# MEETING OF THE BOARD OF COUNTY COMMISSIONERS BOULDER COUNTY AGENDA

#### Docket LU-24-0001: BCPOS Sherwood Creek Restoration

Proposal: Limited Impact Special Use Review to permit 8,843 cubic yards of non-

SHERWOOD CREEK HORIZONTAL CONTROL PLAN

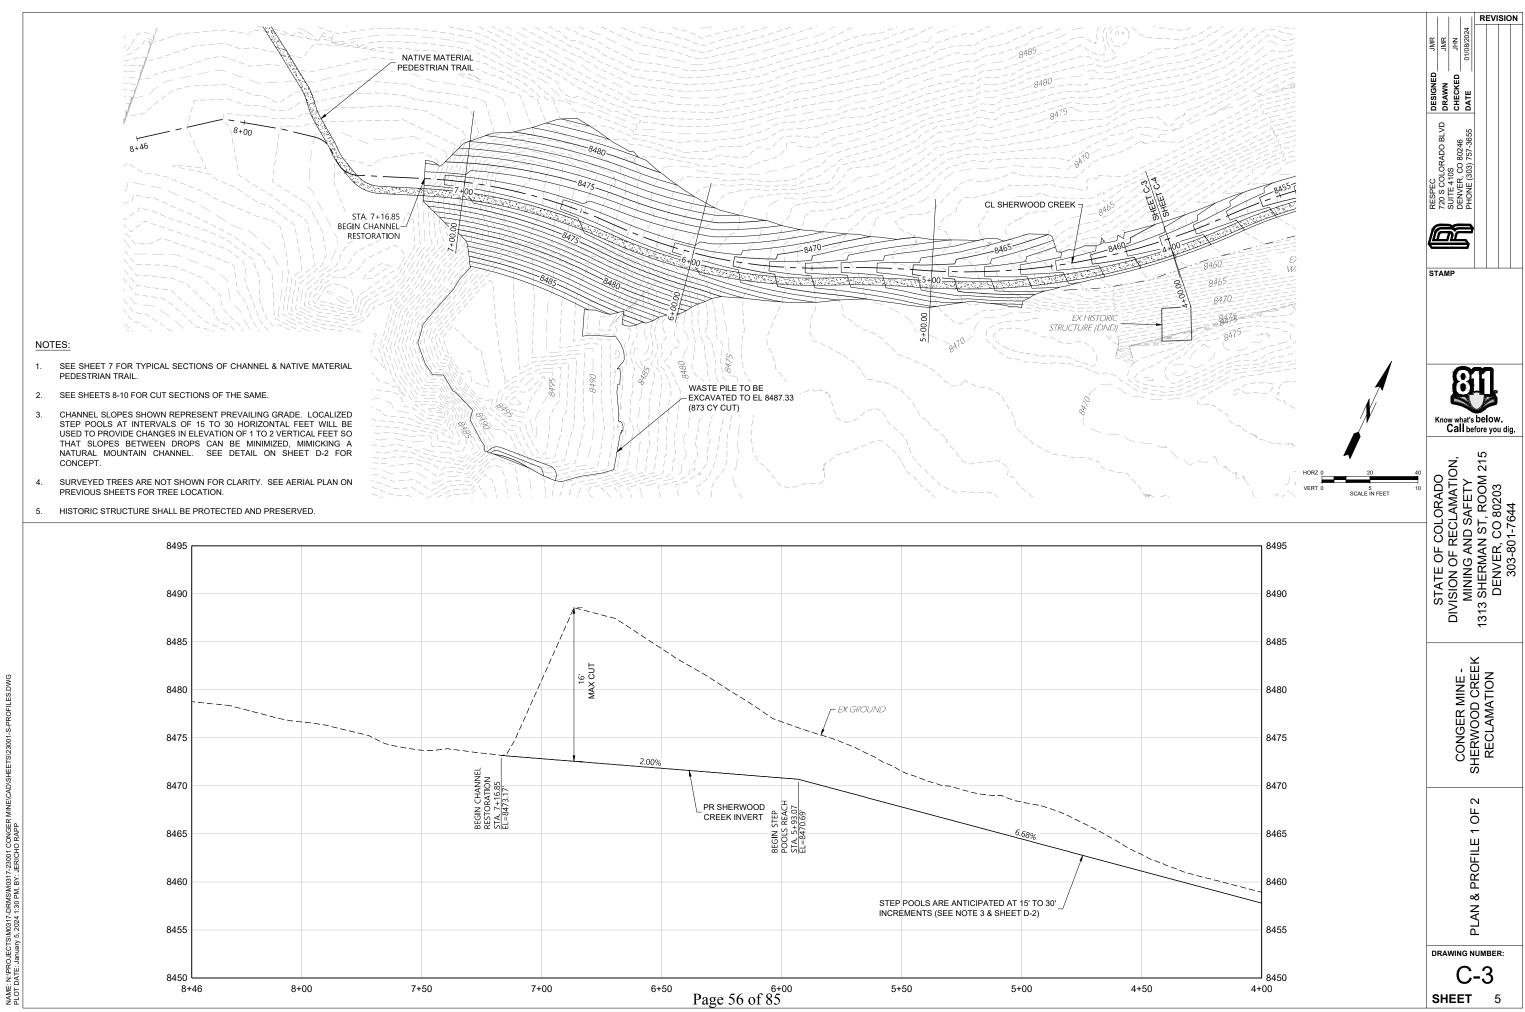
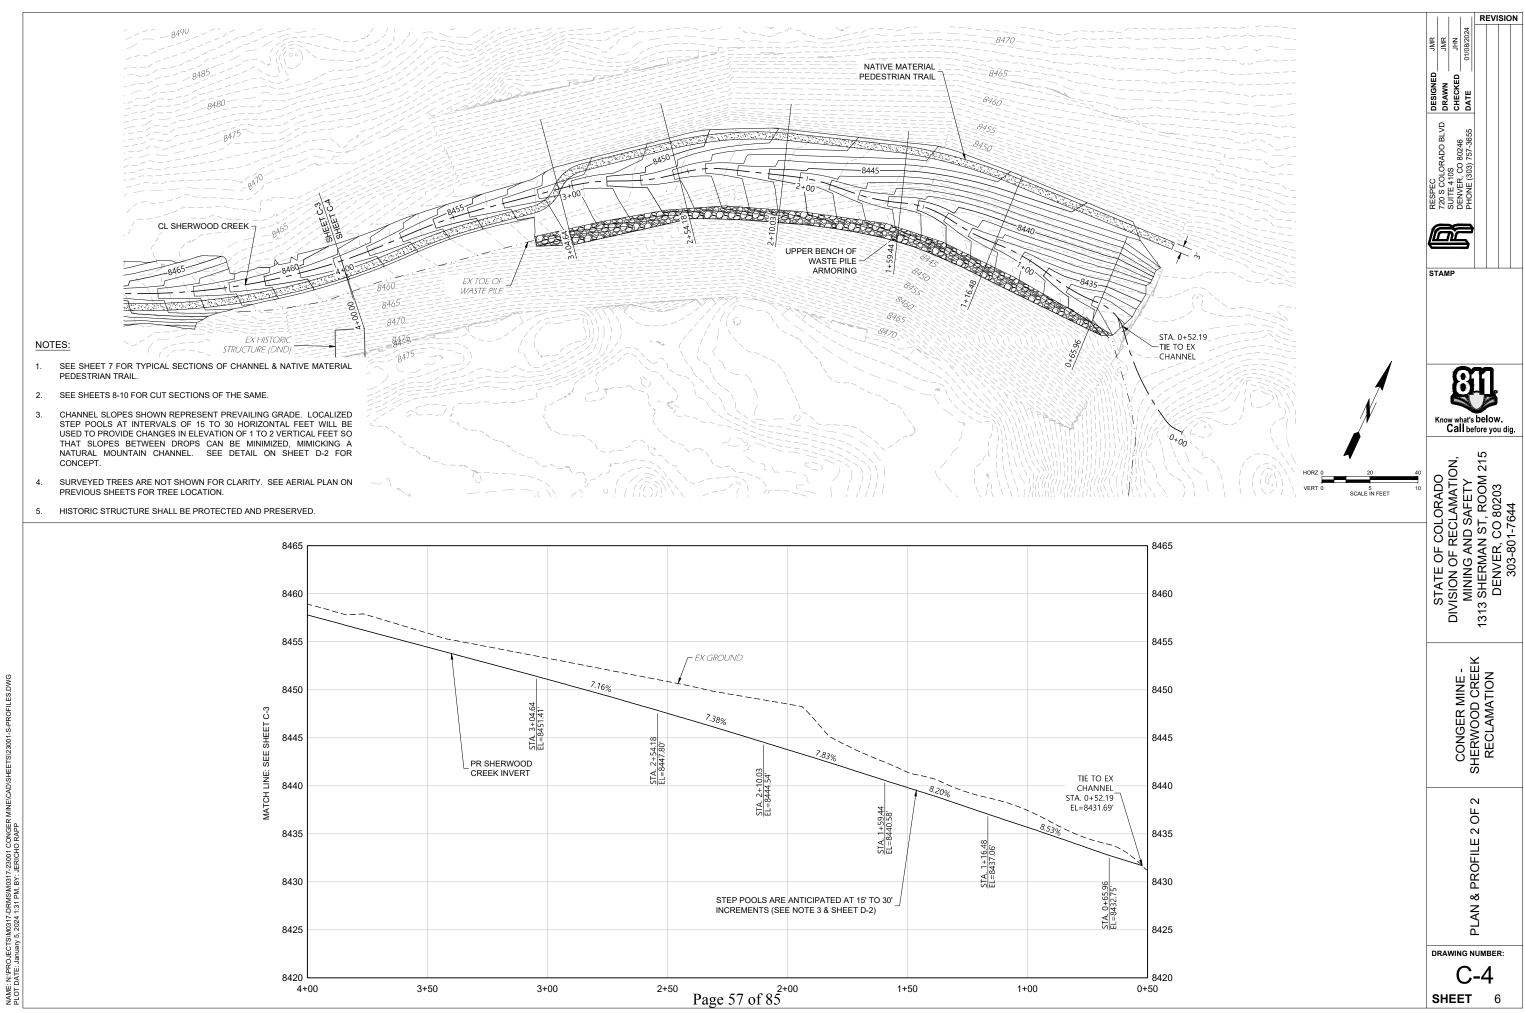
Under "Installation of Grade Control Structures," it is stated that one structure would be completed in the downstream section. Is this the "4" head cut" and access path on Sheet C-1?

Sheet C-1, Note 5 – "Waste rock berm shall be graded down in this area at a later date at the advisement of Boulder County." Staff does not agree. The entire site would be revegetated under this project, and doing the berm "later" would re-disturb a large area. Also, there would be no access to the site for equipment, unless a small skid steer that could negotiate the trail would be sufficient. This would be a huge effort for such a small machine. Staff strongly recommends that the removal of the berm be incorporated into the current project.

SECTIONS

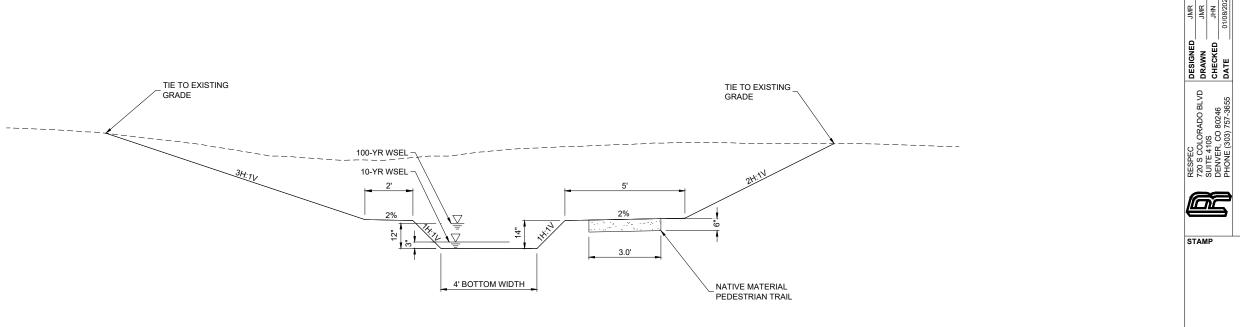
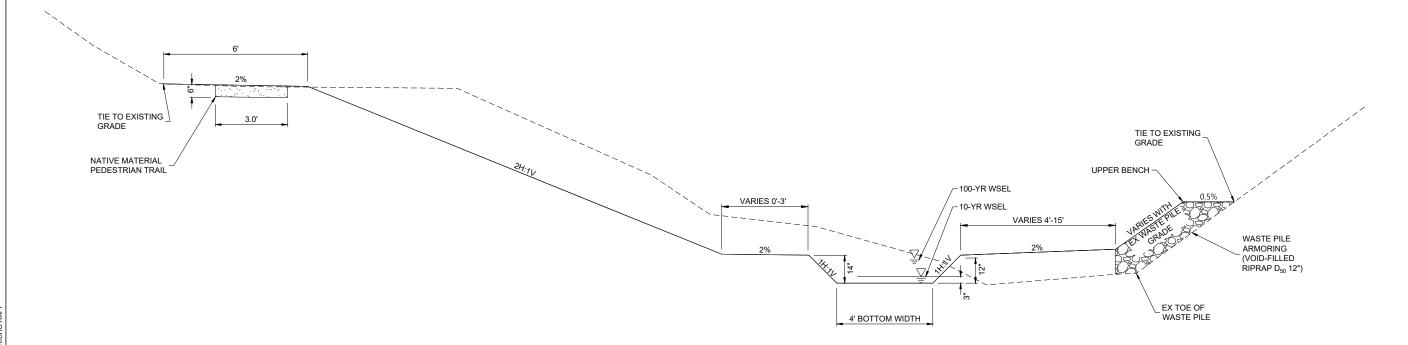
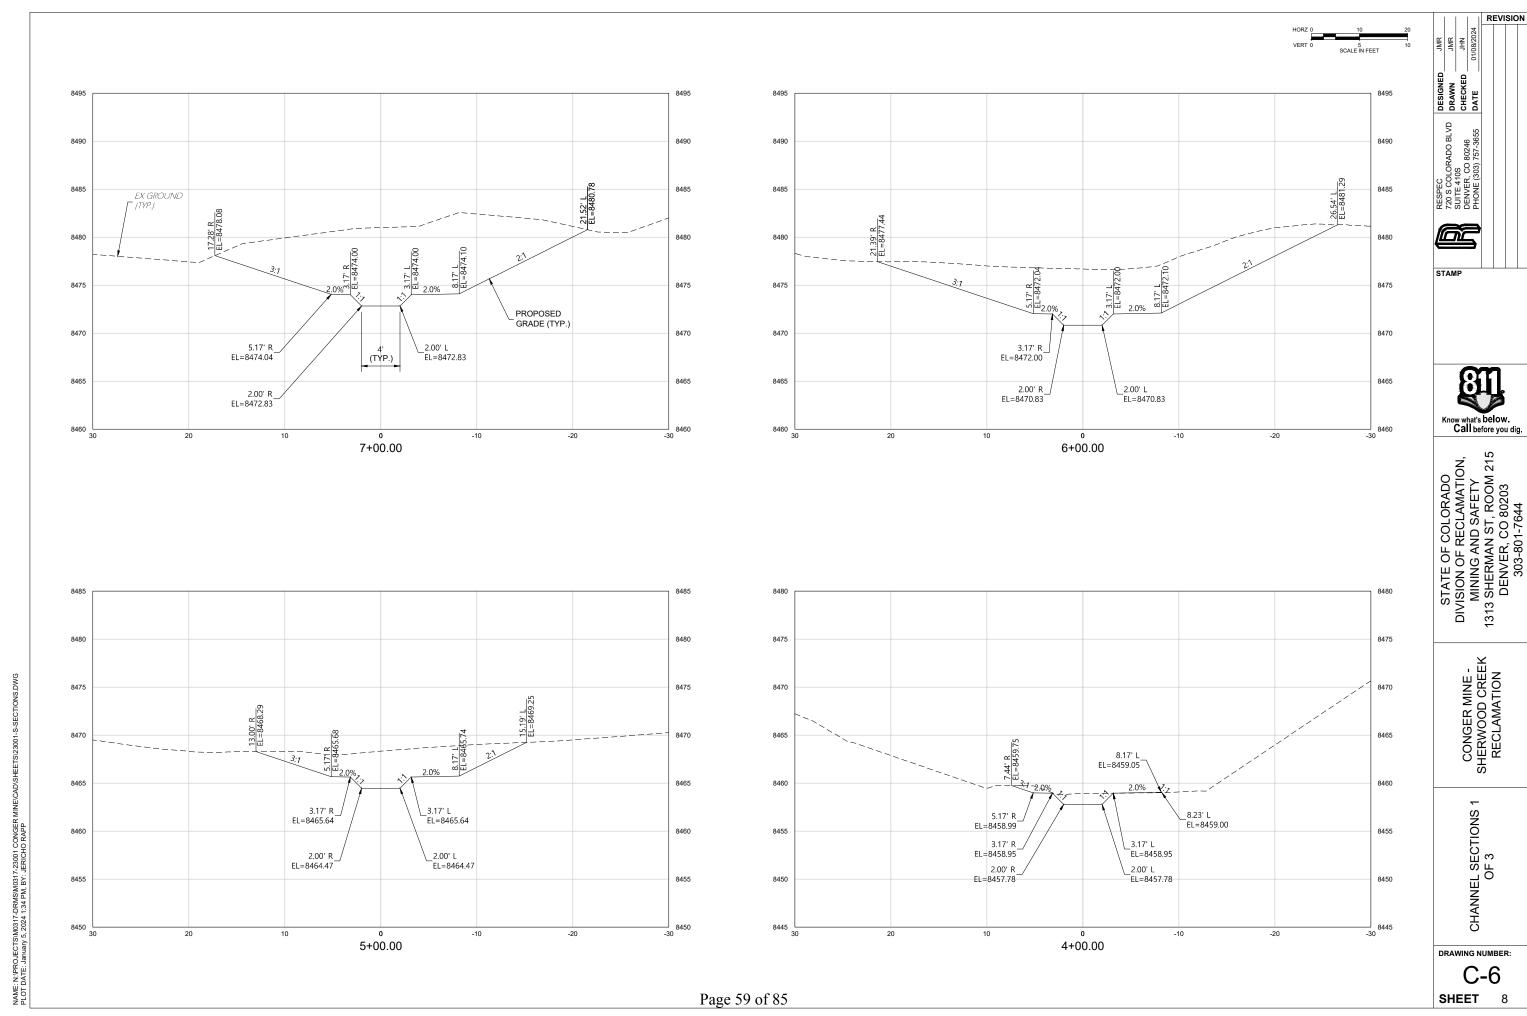
Sheet C-5 – Staff notes that the riprap at the toe of the existing waste pile would be void-filled. This is important, so vegetation could eventually grow on the riprap. Where would this (fine) fill material be sourced?

D-1
SHEET 14

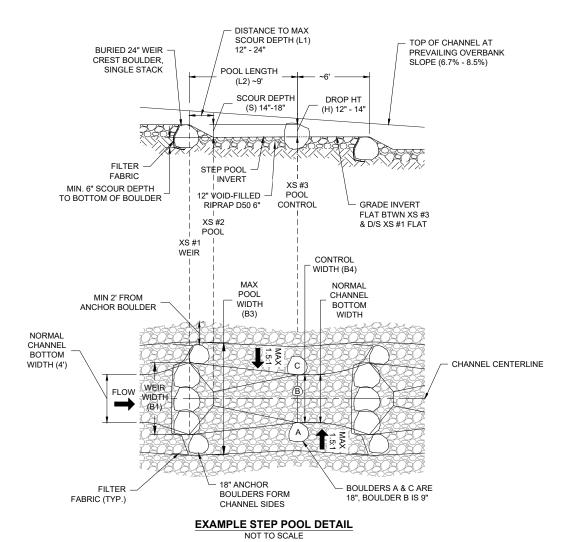
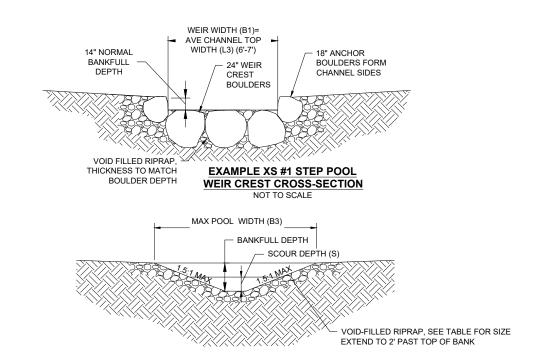
Sheet D-1 – Staff notes that which of the two structure designs would be used will occur later, subject to the new law.
